Re: Starbucks @ Lomas & Washington

4407 Lomas Blvd NE

Grading and Drainage Plan Permanent CO – Accepted

Grading and Drainage Plan

#### IMPERVOIUS AREA – EXISTING CONDITION

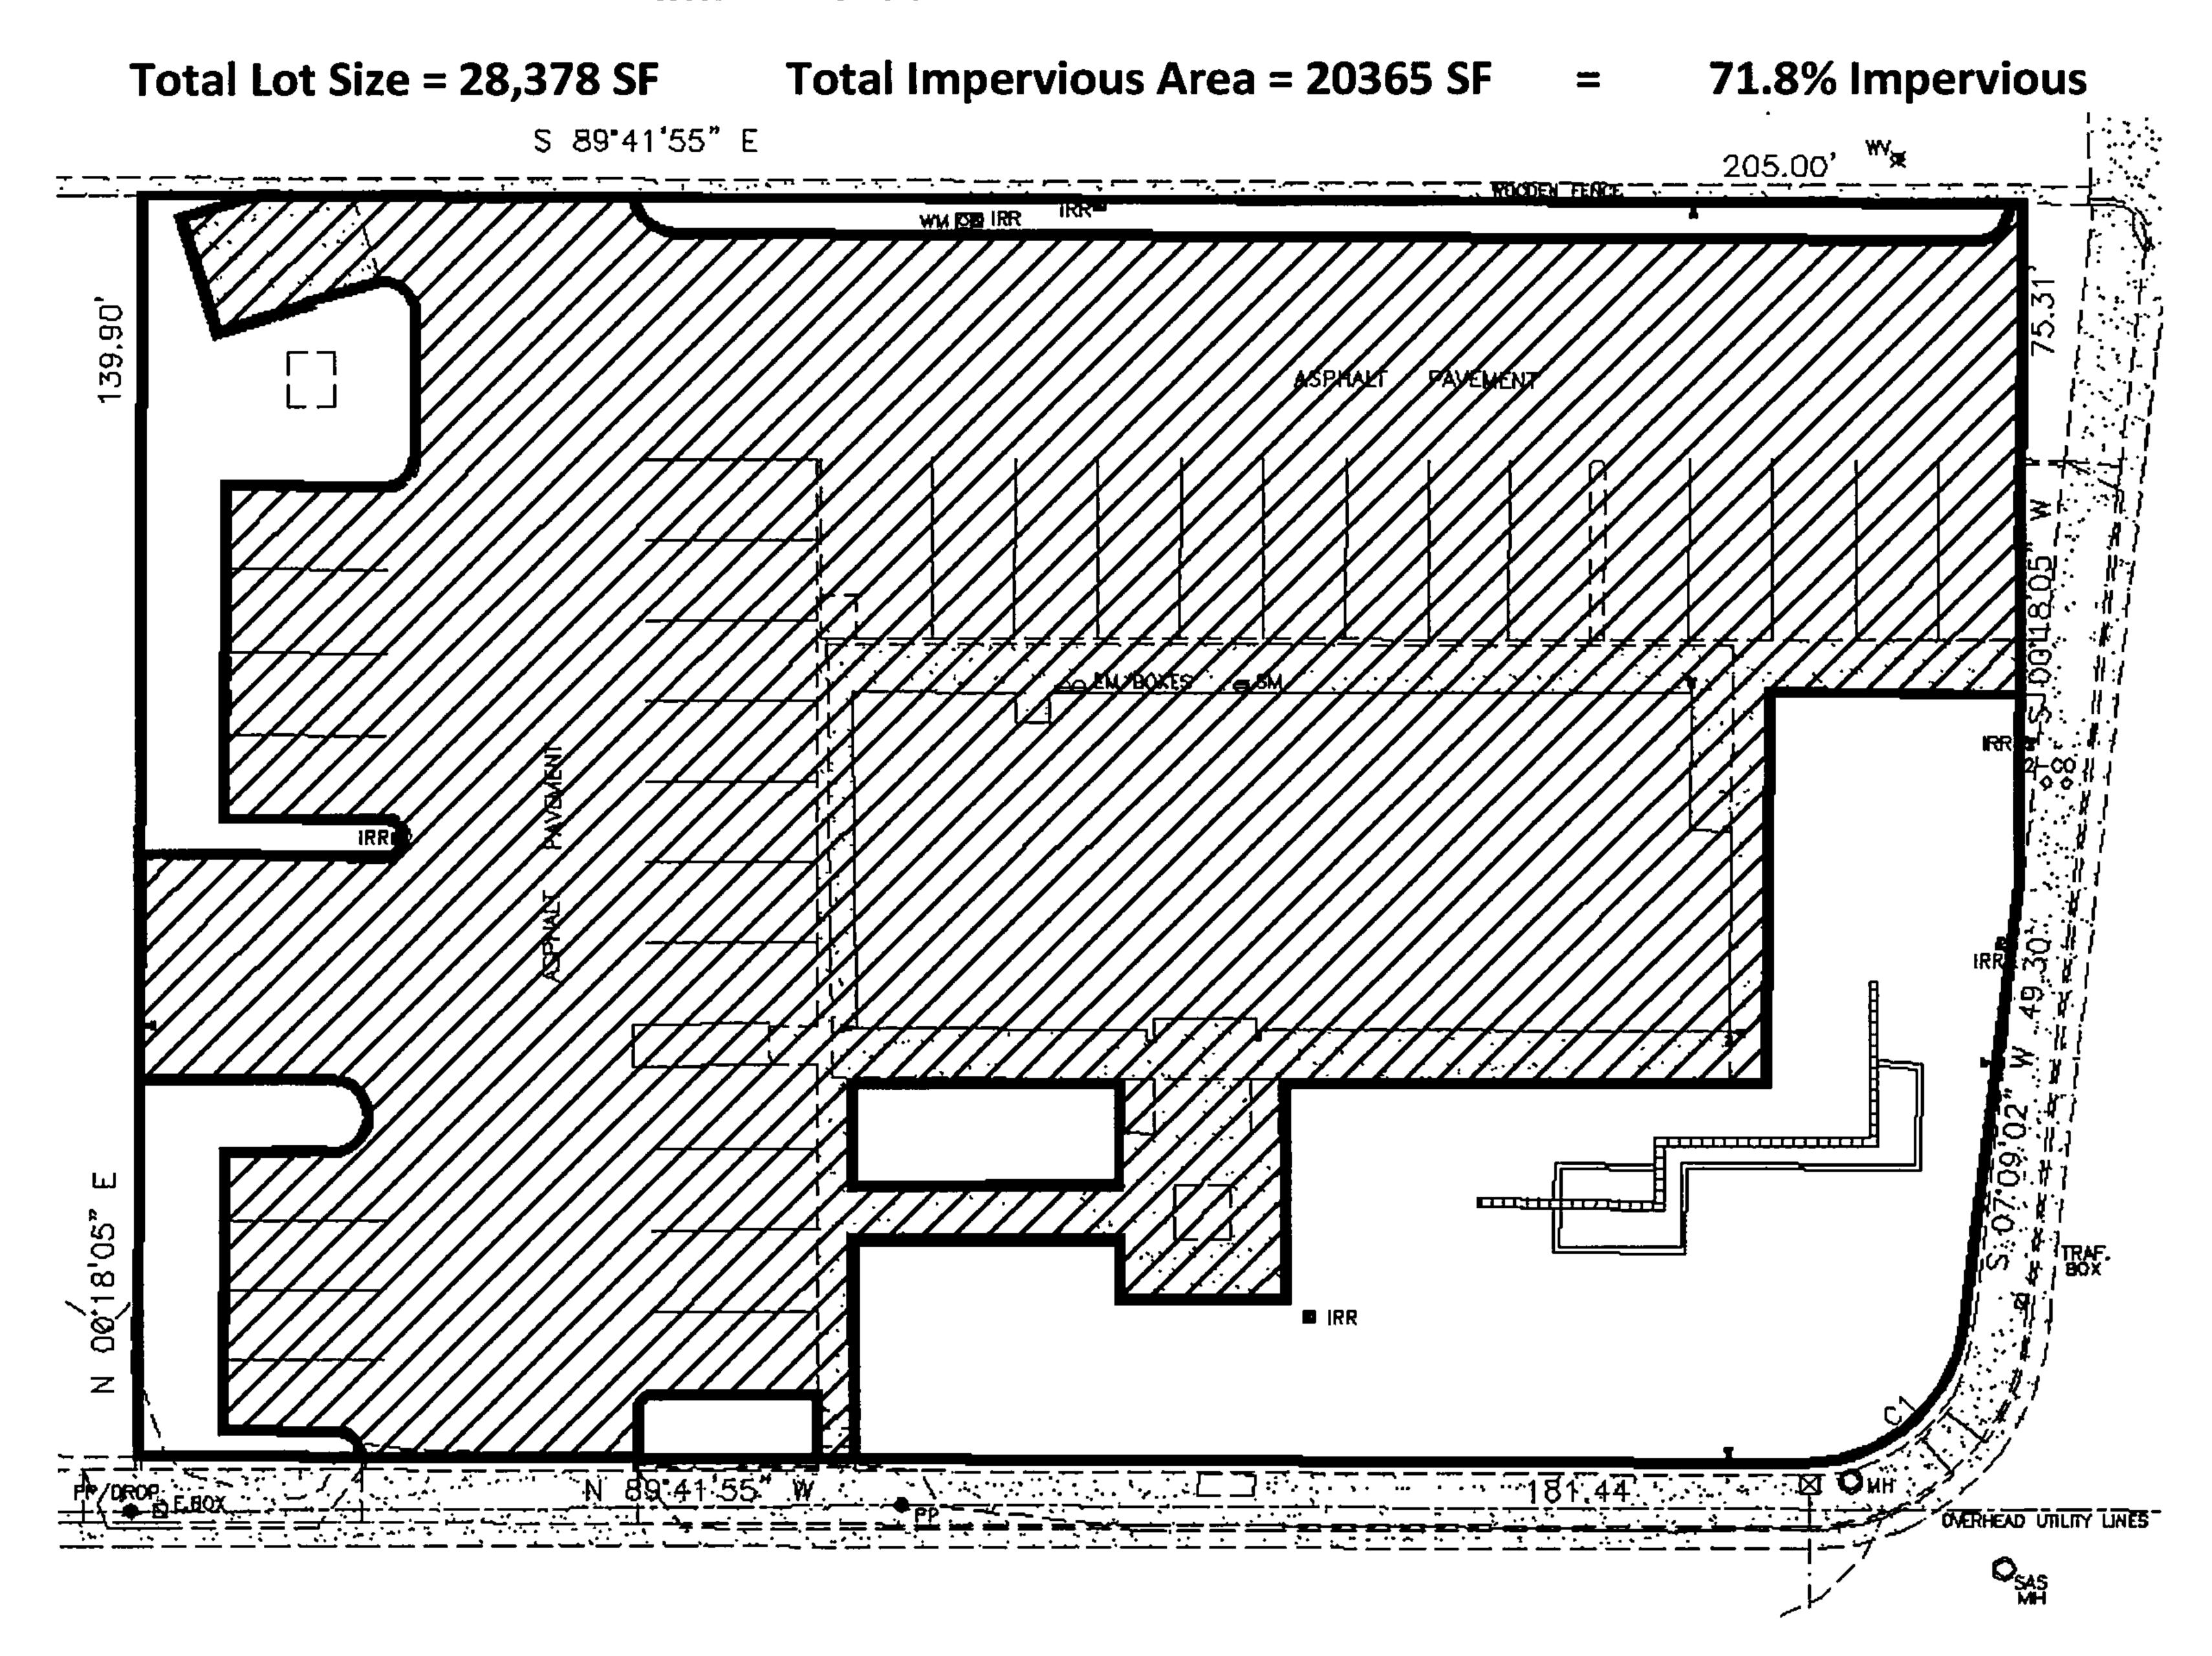
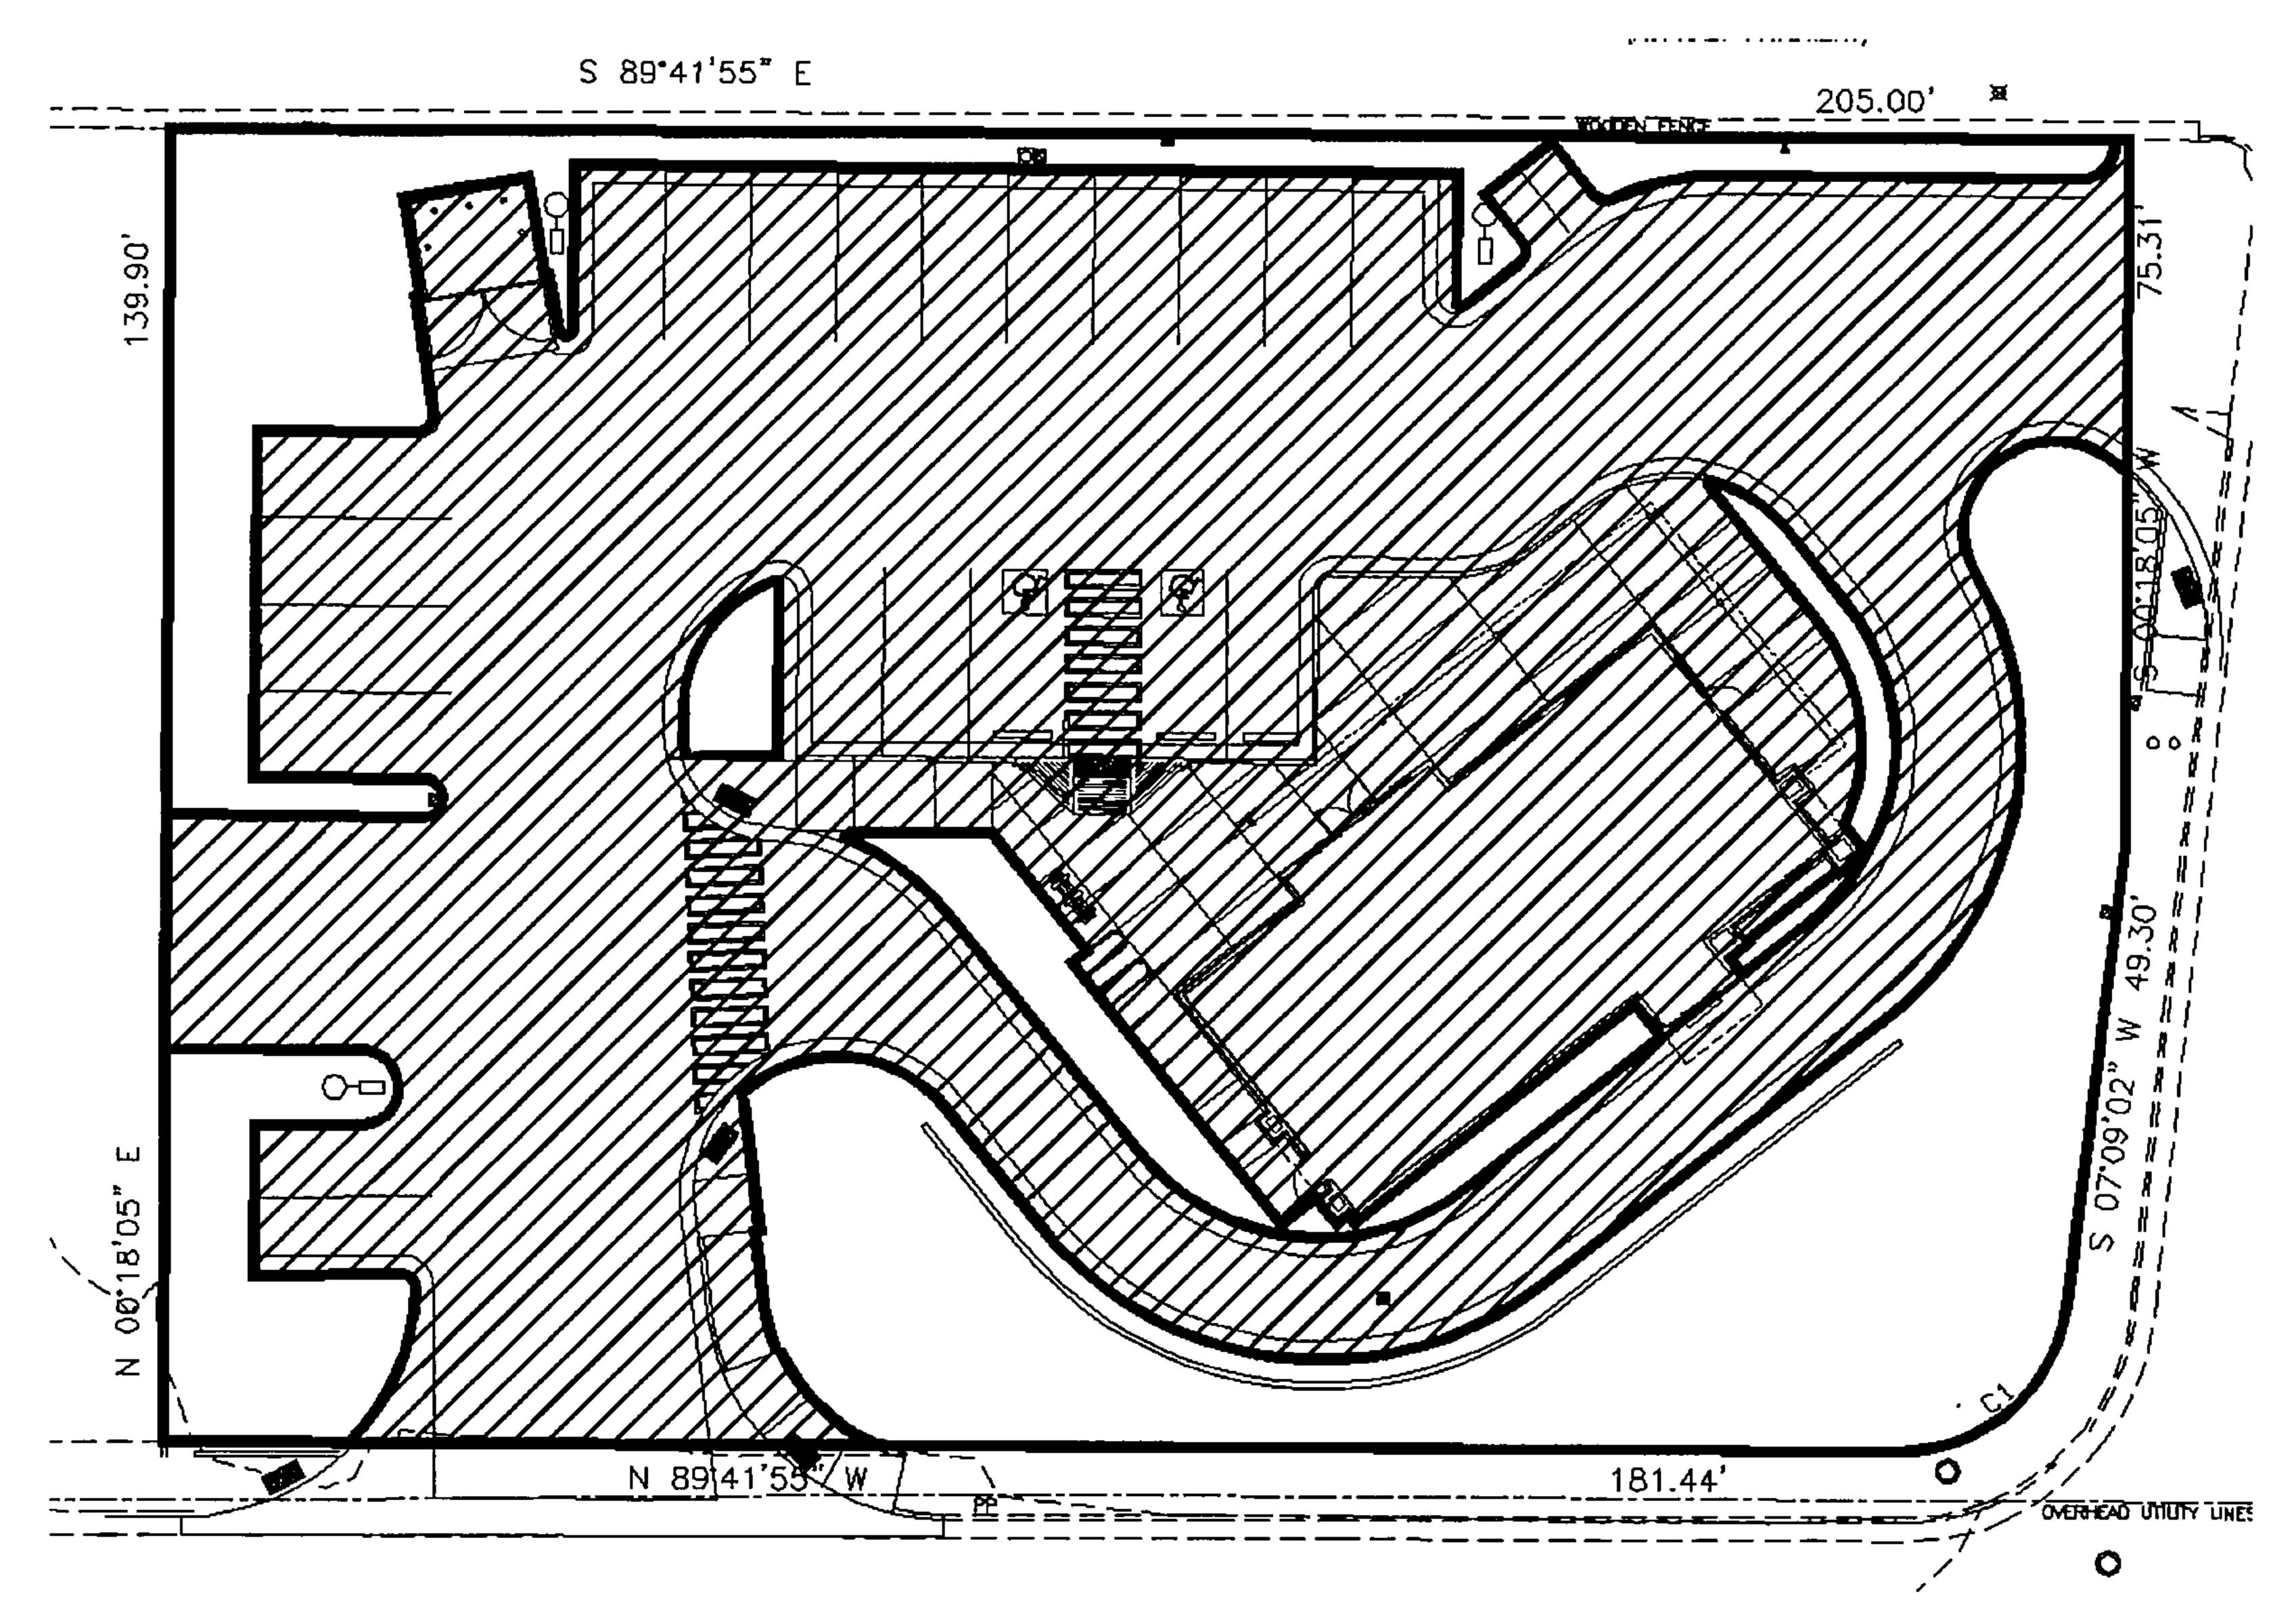
1) Under the Basin Calculations, label the associated impervious area next to the first flush volume for each of the basins. At the bottom end of the Basin Calculations Table, show the total proposed 100-year flow, the total of the impervious areas, and the total of the first flush volume.

2) Provide calculations for the existing 100-year flow for comparison to the proposed 100-year flow.

- 1. First flush (f.f.) summary table has been added to the plan with the following columns:
  - a. Basin number
  - b. Description
  - c. Total basin area (sf)
  - d. % of basin that is impervious
  - e. Area (sf) of basin that is impervious
  - f. First flush volume

The total impervious area and total f.f. volume are provided at the bottom of the table.

- 2. Existing / Proposed calculations for the overall development have been added to the plan.
- 3. I have labeled the volume that is being retained at each of the f.f. retention pond areas.
- 4. The basin draining to the proposed sidewalk culvert (Basin A) has a peak discharge rate of 0.5 cfs. The other curb openings throughout the site will pass between 0.1 and 0.4 cfs. Calculations have been provided in the Supplemental Information packet submitted with this plan.
- 5. The site immediately to the west of this property is not impacted by this development. Referencing the original Grading and Drainage Plan prepared by Victor Chavez dated 7/7/87 (copy included in the Supplemental Information packet), this small basin (Basin 4) will continue to discharge west. The public alley to the north will also continue to accept approximately 1.0 cfs from Basin C.

- 6. Supplemental Information packet included contains the following:
  - a. Impervious Area existing condition
  - b. Impervious Area proposed condition
  - c. Individual drainage basin calculations
  - d. 11x17 of original Grading and Drainage Plan with basins clarified
  - e. Sidewalk culvert and curb opening calculations.
